Rezoning Transportation Analysis

Petition Number: 2020-023

General Location Identifier: Tax ID 05321119

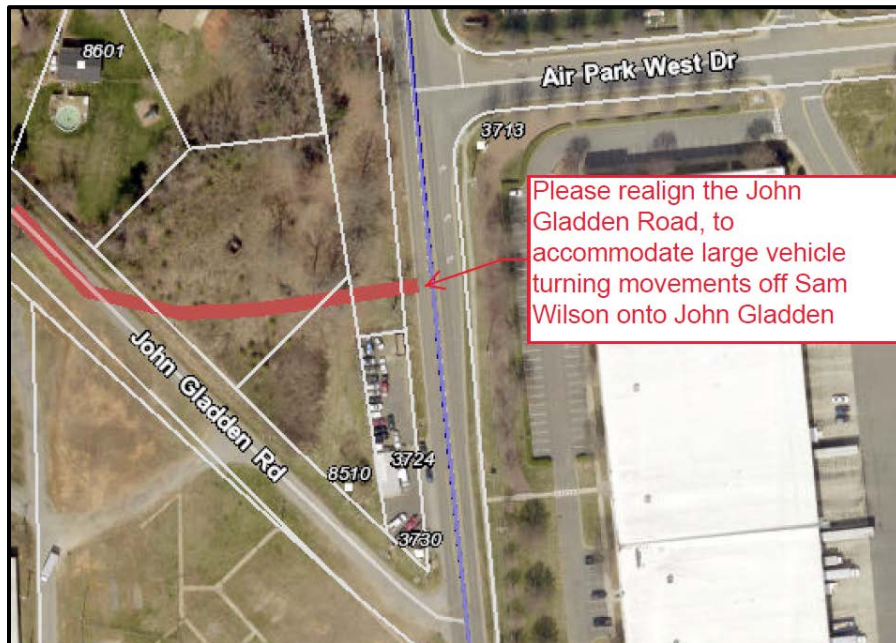
- a. **John Gladden Road:** The future location of curb and gutter is recommended to be placed 17.5 feet from existing road centerline, per Charlotte Land Development Standards Manual (CLDSM) U-06 Local Industrial Street Typical Section. This is an ordinance requirement.

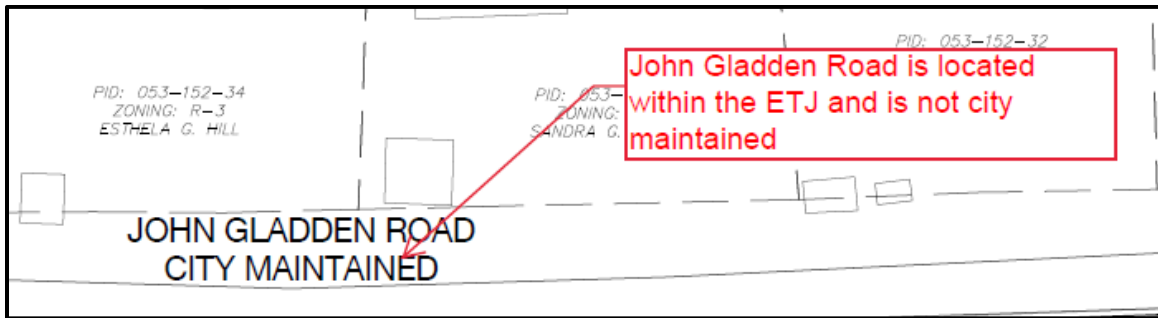
5. We request the petitioner to revise the site plan and conditional note(s) to realign John Gladden Road perpendicularly to Sam Wilson Road, which will likely be needed to accommodate turning movements. This option would involve acquisition of private property.

6. If realigning John Gladden Road is necessary, the petitioner should revise the site plan and conditional note(s) to commit to re-striping a left turn lane on Sam Wilson Road, in coordination with CDOT and NCDOT.

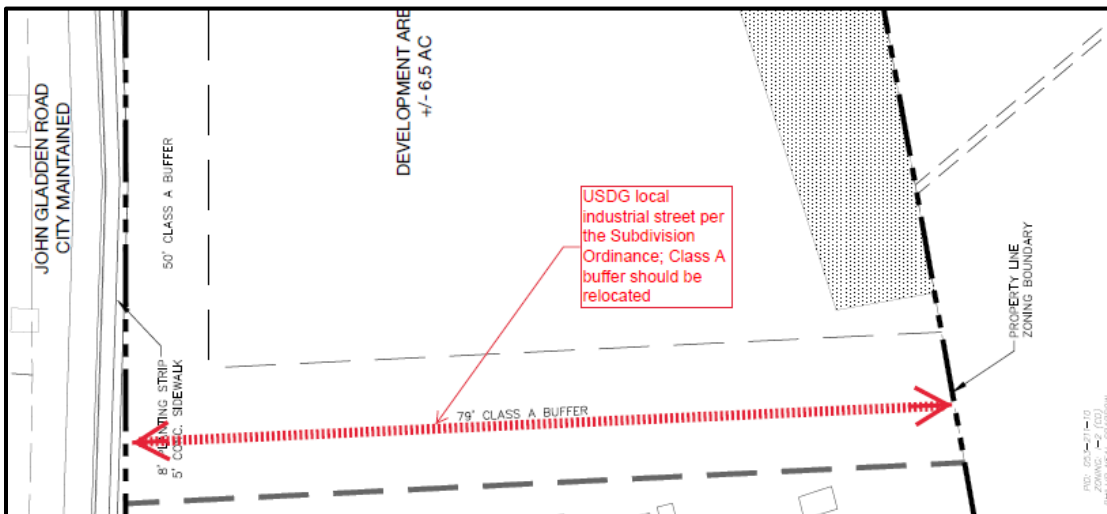
8. The petitioner should revise the site plan and conditional note(s) to include a Subdivision Ordinance required public street, designed per CLDSM std. no. U-06 – Local Industrial Street, as shown below.
